APR 2 0 2001 LRN-01-0115

RESPONSE TO APRIL 3, 2001 REQUEST FOR ADDITIONAL INFORMATION IN REGARDS TO REQUEST FOR LICENSE AMENDMENT INCREASED LICENSED POWER LEVEL SALEM GENERATING STATION, UNIT NOS. 1 AND 2 FACILITY OPERATING LICENSE DPR-70 AND DPR-75 DOCKET NOS. 50-272 AND 50-311

ATTACHMENT 1 SALEM GENERATING STATION UNIT NOS. 1 AND 2 FACILITY OPERATING LICENSE DPR-70 AND DPR-75 DOCKET NOS. 50-272 AND 50-311 RESPONSE TO REQUEST FOR ADDITIONAL INFORMATION INCREASED LICENSED POWER LEVEL

SALEM GENERATING STATION UNIT NOS. 1 AND 2 FACILITY OPERATING LICENSE DPR-70 AND DPR-75 DOCKET NOS. 50-272 AND 50-311 CHANGE TO FACILITY OPERATING LICENSES

TABLE 3.7-1

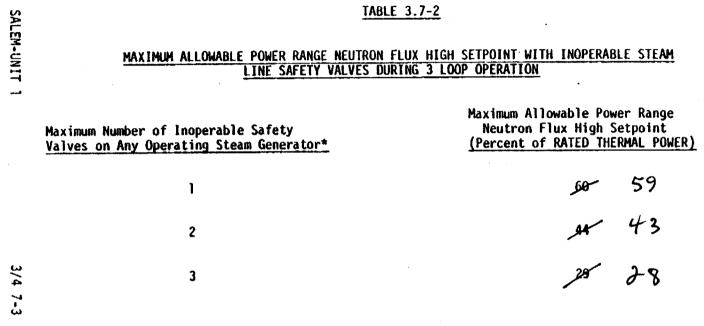
MAXIMUM ALLOWABLE POWER RANGE NEUTRON FLUX HIGH SETPOINT WITH INOPERABLE STEAM LINE SAFETY VALVES DURING 4 LOOP OPERATION

1 85 87 2 63 3 41 12

* At least two safety valves shall be OPERABLE on the non-operating steam generator.

B 3/4 7-1

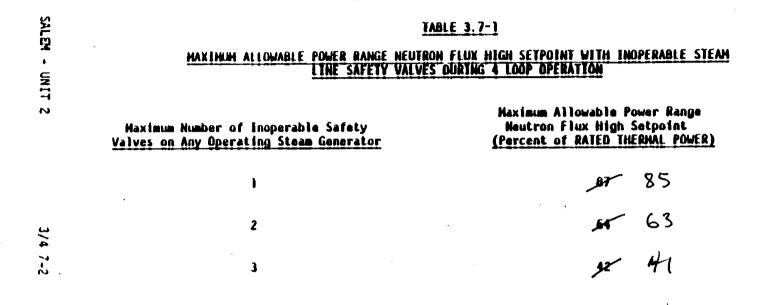
The OPERABILITY of the main steam line code safety values ensures that the secondary system pressure will be limited to within 110% of its design pressure of 1085 psig during the most severe anticipated system operational transient. The maximum relieving capacity is associated with a turbine trip from 100% RATED THERMAL POWER coincident with an assumed loss of condenser heat sink (i.e., no steam bypass to the condenser). 16.66×10^6 15.10×10^6

The specified valve lift settings and relieving capacities are in accordance with the requirements of Section III of the ASME Boiler and Pressure Code, 1971 Edition. The total relieving capacity for all valves on all of the steam lines is 16,655,268 lbs/hr which is 115 percent of the total secondary steam flow of 14,459,360 lbs/hr at 100% RATED THERMAL POWER. A minimum of 2 OPERABLE safety valves per OPERABLE steam generator ensures that sufficient relieving capacity is available for the allowable THERMAL POWER restriction in Table 3.7-2.

STARTUP and/or POWER OPERATION is allowable with safety valves inoperable within the limitations of the ACTION requirements on the basis of the reduction in secondary system steam flow and THERMAL 'POWER required by the reduced reactor trip settings of the Power Range Neutron Flux channels. The reactor trip setpoint reductions are derived on the following bases:

$$SP = \frac{(X) - (Y)(V)}{X} \times (109)$$

$$SP = \frac{(X) - (Y)(U)}{X} \times (75)$$
